RE: NHTSA Recall Number 08E-064; Supplemental to SKF's Notice dated October 16, 2008

SKF NOTICE TO END USERS

NHTSA Recall #08E-064 of SKF BR930361 hub bearing assembly; SKF Recall # PRO 08-029US/CA

SKF NOTICE TO ITS DISTRIBUTION CUSTOMERS

Figure 1 Defective

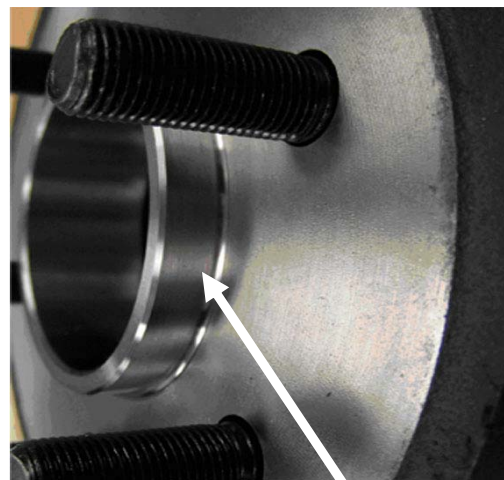
The rotor pilot for the hub bearing assembly was made too long. This results in the wheel to not be seated fully against the hub flange face during mounting. Improper seating of the wheel can result in excessive vibration, brake rotor noise, difficulty removing the wheel after installation and operation of the vehicle, and possibly wheel-end separation during vehicle operation. **Should the wheel-end separation occur, the driver could lose control of the vehicle, possibly resulting in a crash.**

1. Raise and support the vehicle following the manufacturer's guidelines and remove the front wheel.
2. Carefully examine the center brake rotor pilot depth. ***The affected hub bearing assembly will have a noticeable visible step just above where the brake rotor is seated.*** Refer to Figures 1 & 2. Figure 1 illustrates the incorrectly machined hub and brake rotor mounting set up. Figure 2 illustrates the correctly machined hub and brake rotor mounting set up.

If you have identified a hub bearing assembly that is defective, remove the defective hub assembly and replace it with a non-defective replacement hub assembly using the manufacturers recommended repair procedures. Return the defective hub assembly to the place of purchase for reimbursement as identified above.

Figure 1 Defective

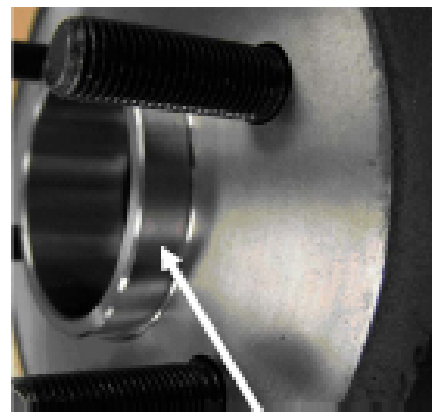
1. Raise and support the vehicle following the manufacturer's guidelines and remove the front wheel.
2. Carefully examine the center brake rotor pilot depth. *The affected hub bearing assembly will have a noticeable visible step just above where the brake rotor is seated. Refer to Figures 1 & 2. Figure 1 illustrates the incorrectly machined hub and brake rotor mounting set up. Figure 2 illustrates the correctly machined hub and brake rotor mounting set up.*

3. If you have identified a hub bearing assembly that is defective, remove the defective hub assembly and replace it with a non-defective replacement hub assembly using the manufacturers recommended repair procedures. Caution: Verify that the replacement SKF BR930361 is not a defective part by repeating step 2 listed above.
4. Complete the information on the front side of this form; contact your SKF parts distributor for assistance in completing the WD/DC and Jobber Information sections. When completed, send the form and the defective hub assembly if applicable to SKF at the address indicated on the form.
